DELAWARE DEPARTMENT OF TRANSPORTATION	ADDENDUMS / REVISIONS	NOT TO SCALE	SR1 / I-95 INTERCHANGE	CONTRACT 28-090-03	BRIDGE NO.	TYPICAL SECTIONS	SHEET NO. 10
	ADDENDUM NO. 3 CHANGED ITEM NO., 02/18/2011, RLS			COUNTY NEW CASTLE	DESIGNED BY:		TOTAL SHTS. 803
					CHECKED BY:

DELAWARE DEPARTMENT OF TRANSPORTATION	ADDENDUMS / REVISIONS ADDENDUM NO. 3 CHANGED ITEM NO., ADDED O.H. SIGN REMOVAL, 02/18/2011 RLS	SCALE 0 50 100 150 FEET	SR1 / I-95 INTERCHANGE	CONTRACT 28-090-03 COUNTY NEW CASTLE	BRIDGE NO. DESIGNED BY: CHECKED BY:	CONSTRUCTION PLAN

DELAWARE DEPARTMENT OF TRANSPORTATION	ADDENDUMS / REVISIONS: ADDENDUM NO. 3 VOIDED SHEET; MODIFIED ITMS DESIGN SEE SHEET 711A, 02/18/2011, JCR	SCALE 0 50 100 150 FEET	SR1 / I-95 INTERCHANGE	CONTRACT 28-090-03; COUNTY NEW CASTLE; BRIDGE NO.; DESIGNED BY:; CHECKED BY:	SIGNING, STRIPING & CONDUIT PLAN; SSC-1; SHEET NO. 711; TOTAL SHTS. 803

ADDENDUMS / REVISIONS
ADDENDUM NO. 3 THIS SHEET 717A
REPLACES VOIDED SHEET 717
02/18/2011, JCR

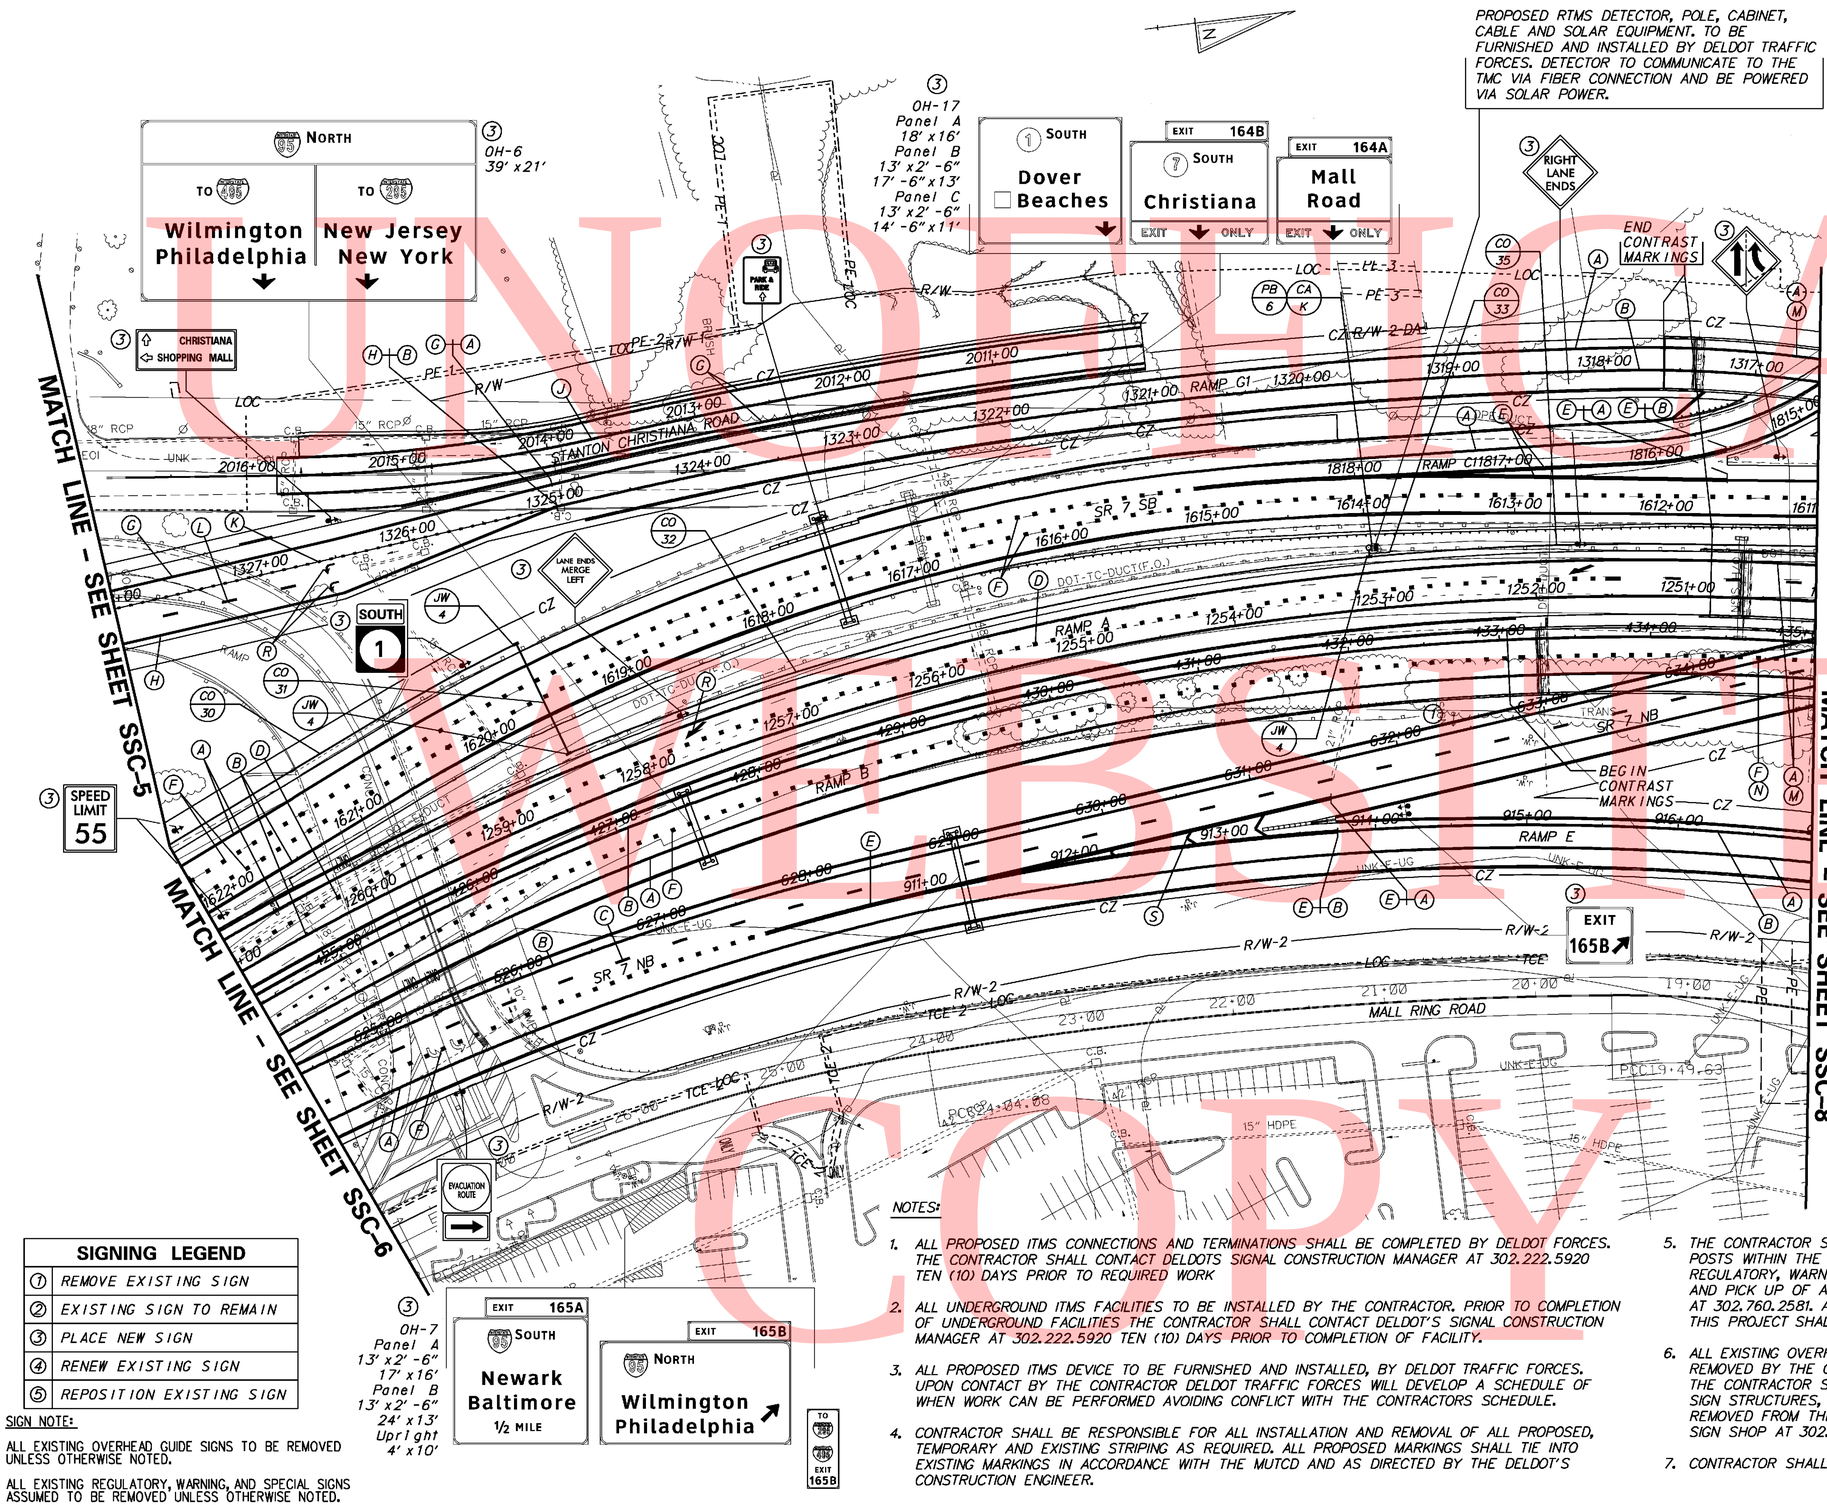
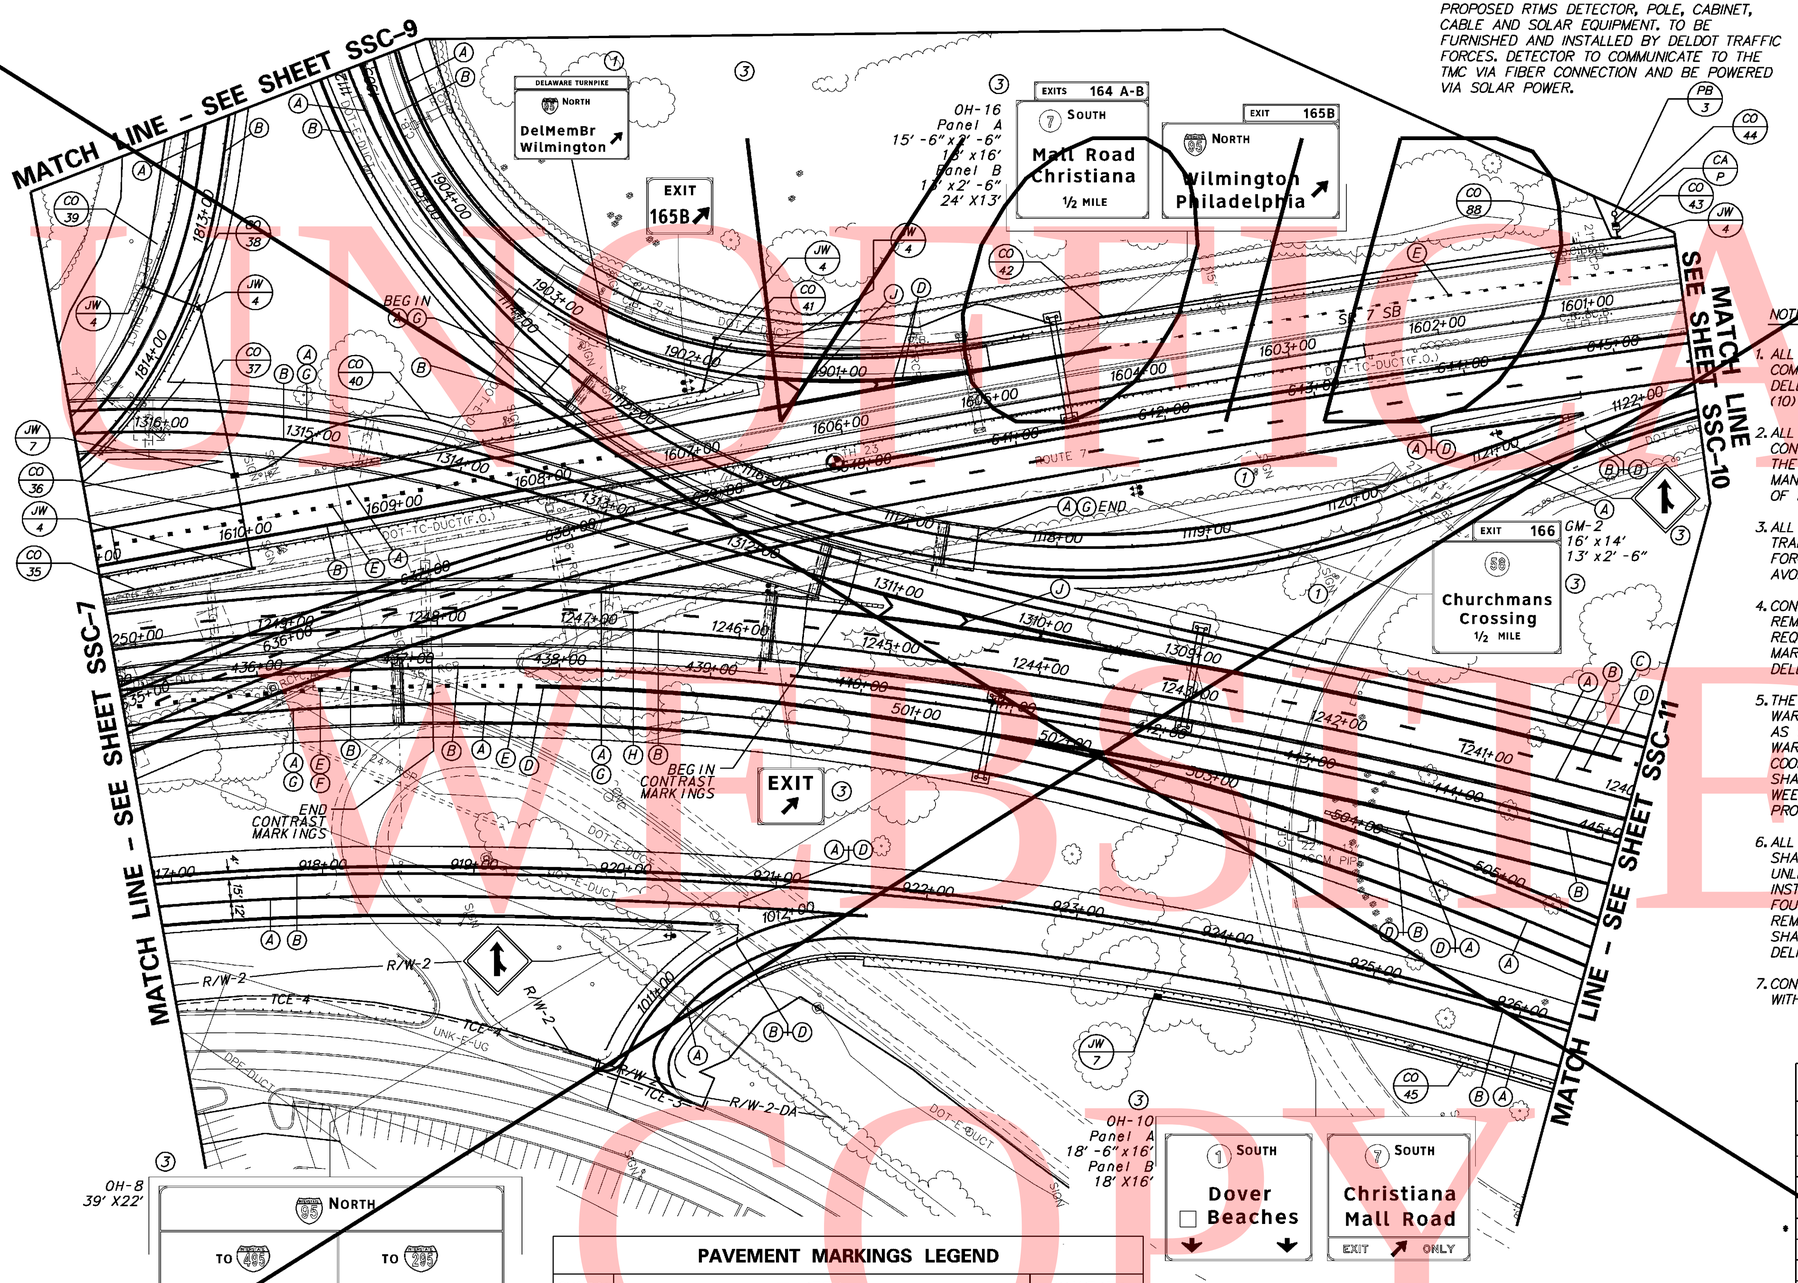
ADDENDUMS / REVISIONS
ADDENDUM NO. 3 VOIDED SHEET 717
MODIFIED ITMS DESIGN SEE SHEET 717A, 02/18/2011, JCR

CR*	*OF CON	SIZE	LENGTH	B/T/O	AMOUNT AND TYPE OF CABLE/ WIRE
30	Pathway Information Shown on Sheet SSC-6				
31	1	4"	82'	B	Comm. Cable
32	1	4"	550'	T	Comm. Cable
33	2	2.5"	10'	T	Comm. Cable
34					
* 35	1	4"	400'	T	Comm. Cable

ADDENDUMS / REVISIONS
ADDENDUM NO. 3 THIS SHEET 718A
REPLACES VOIDED SHEET 718
02/18/2011, JCR

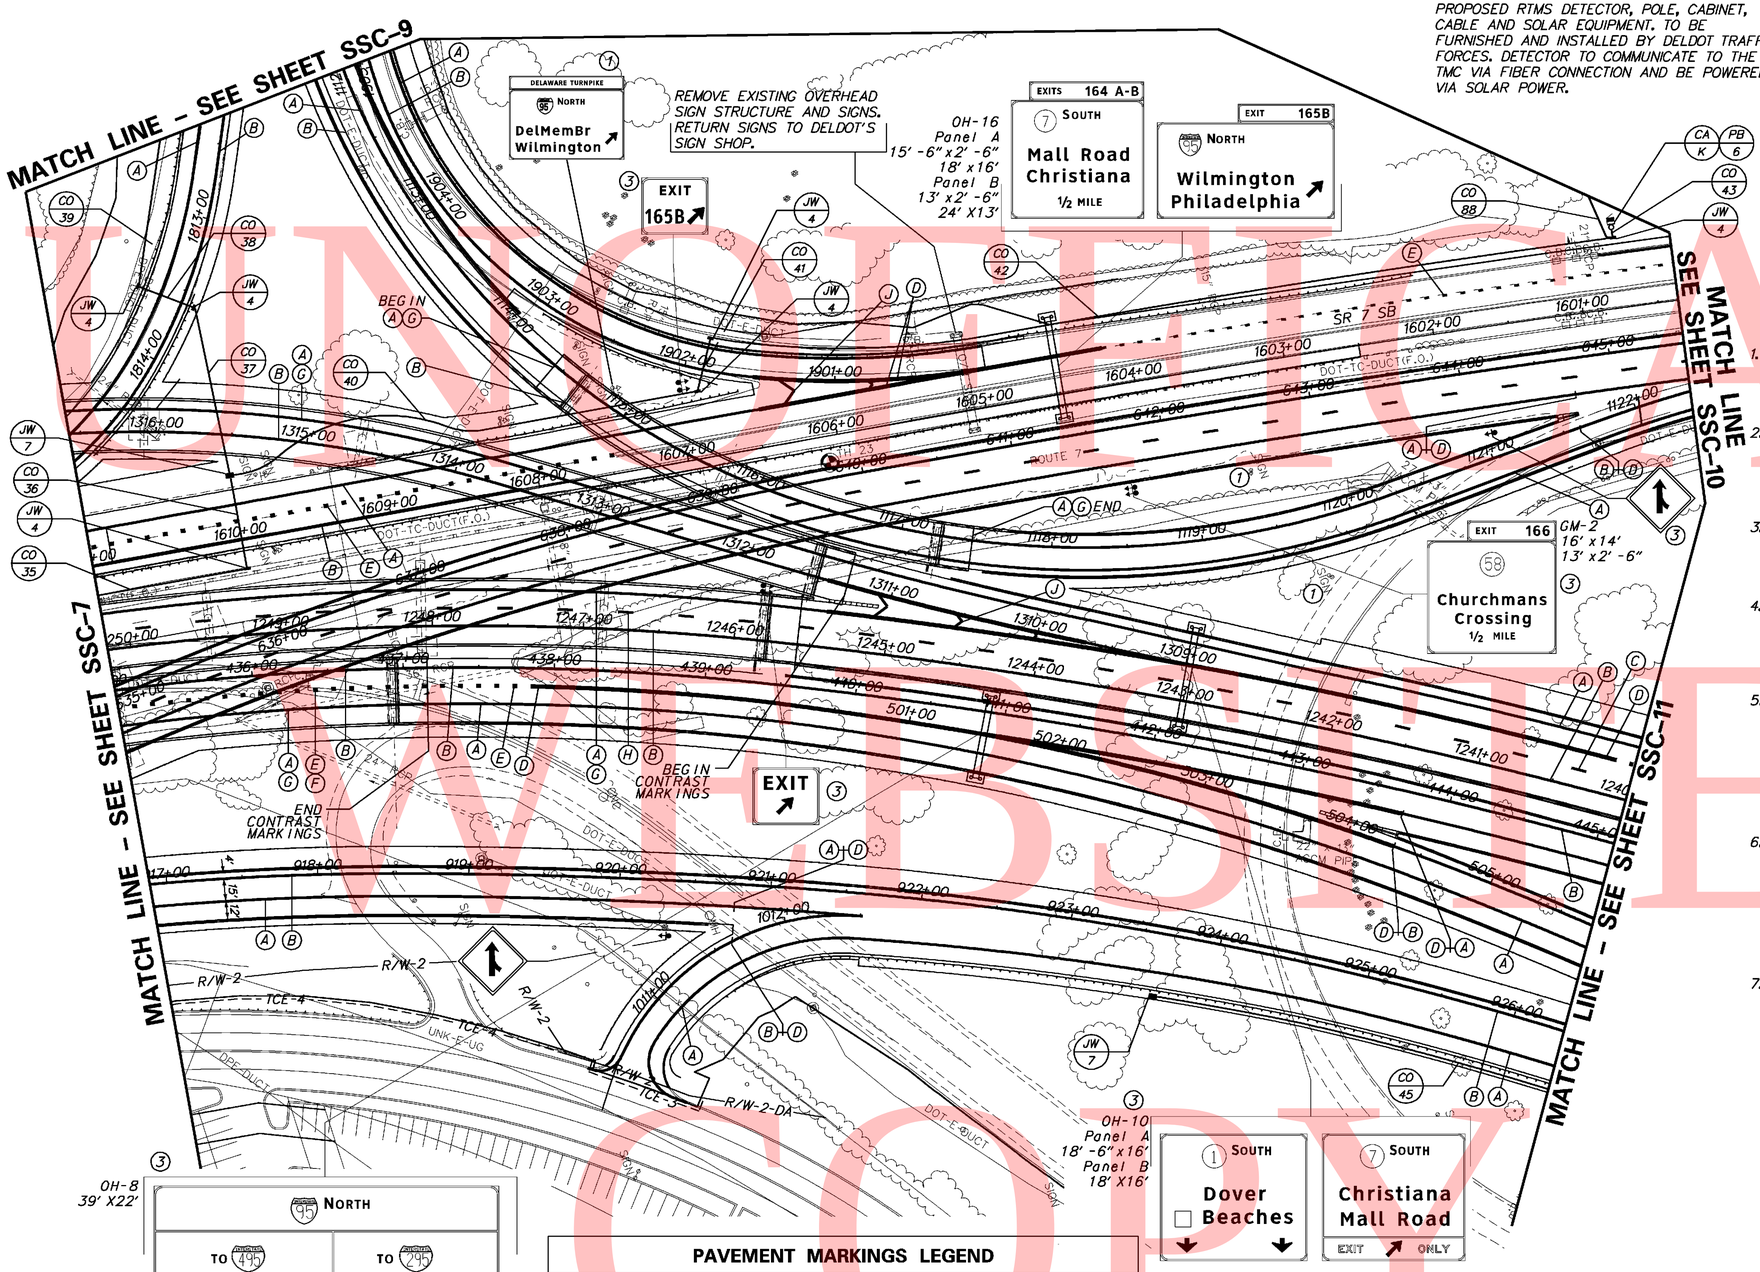
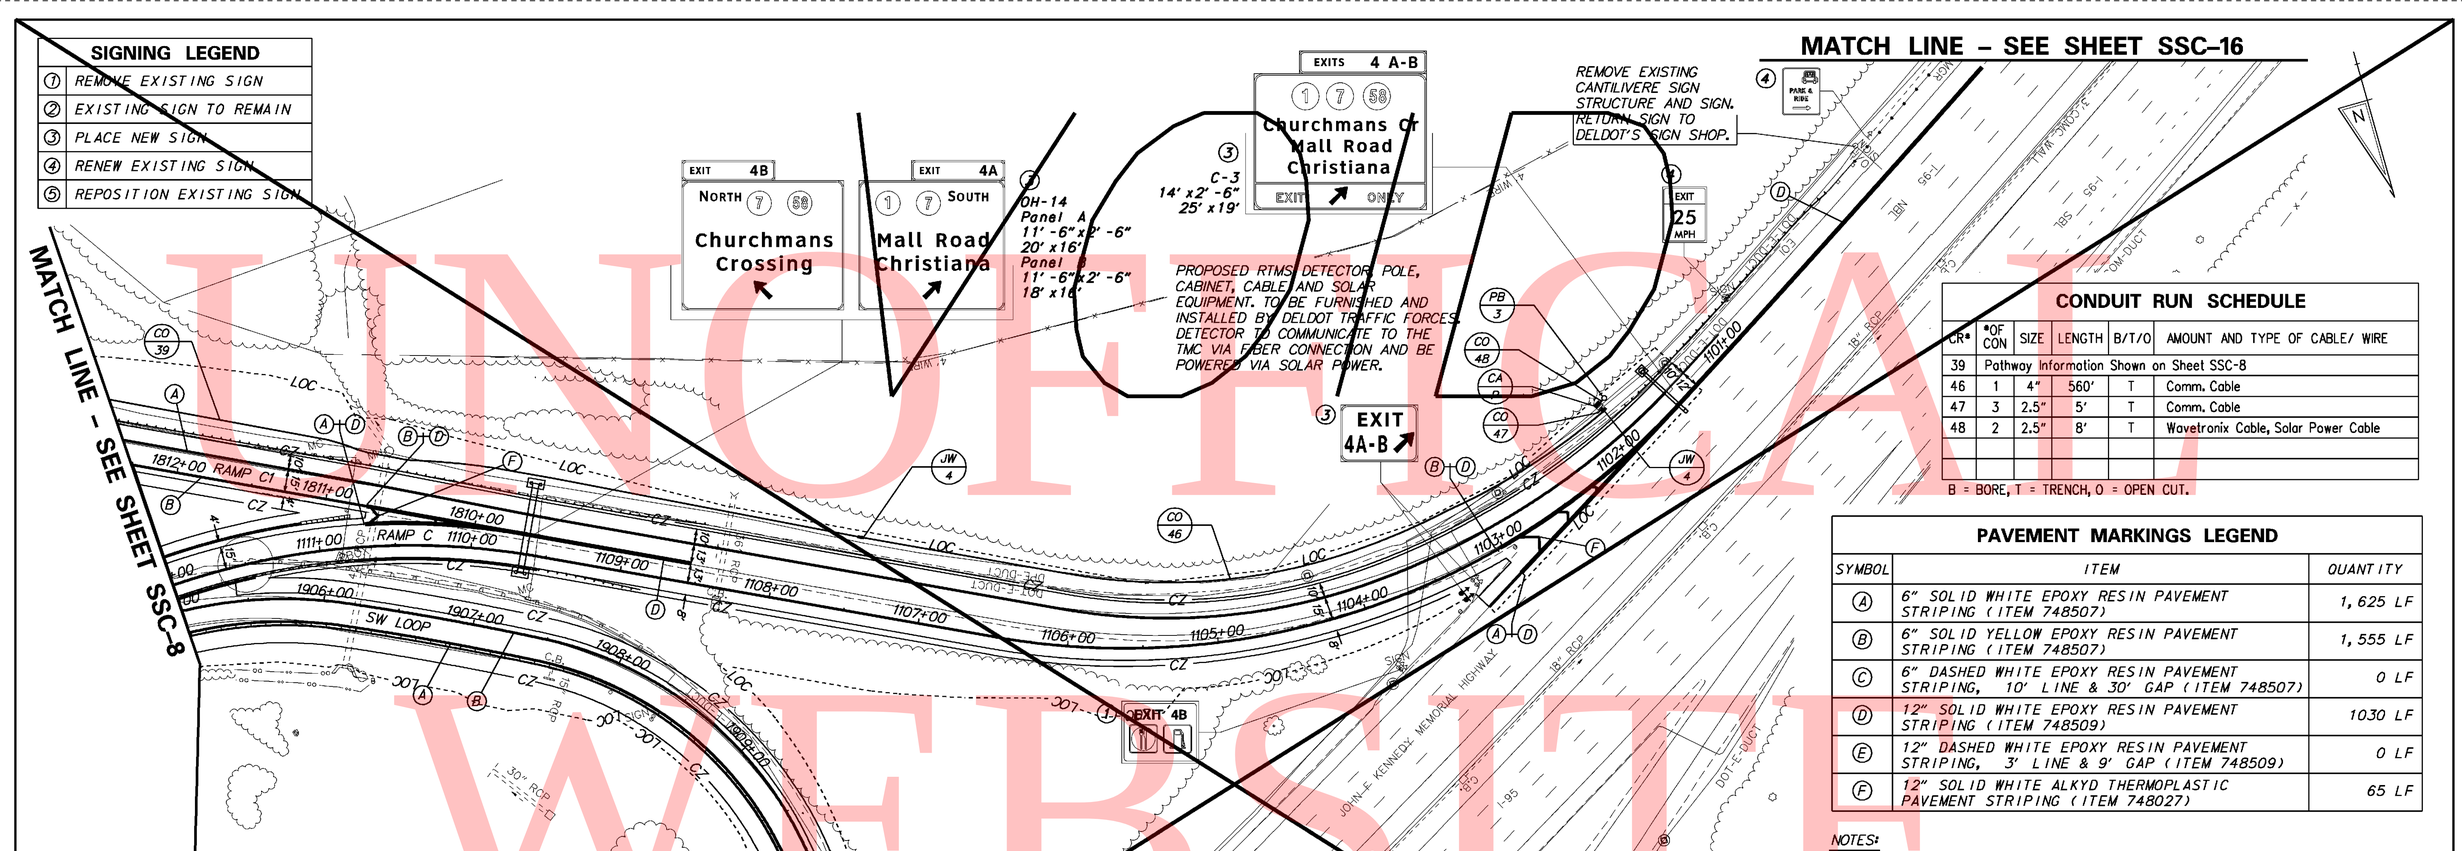
ADDENDUMS / REVISIONS	
ADDENDUM NO. 3 VOIDED SHEET 718	
MODIFIED ITMS DESIGN SEE SHEET 718A, 02/18/2011, JCR

CR*	*OF CON	SIZE	LENGTH	B/T/O	AMOUNT AND TYPE OF CABLE/ WIRE
	35	Pathway Information Shown on Sheet SSC-7				
	36	1	4"	65'	B	Comm. Cable
	37	1	4"	120'	T	Comm. Cable
	38	1	4"	40'	B	Comm. Cable
*	39	1	4"	600'	T	Comm. Cable
	40	1	4"	310'	T	Comm. Cable
	41	1	4"	35'	B	Comm. Cable
	42	1	4"	600'	T	Comm. Cable
	43	2	2.5"	10'	T	Comm. Cable
	44					
**	45	1	4"	600'	T	Empty
***	88	1	4"	225'	T	Comm. Cable
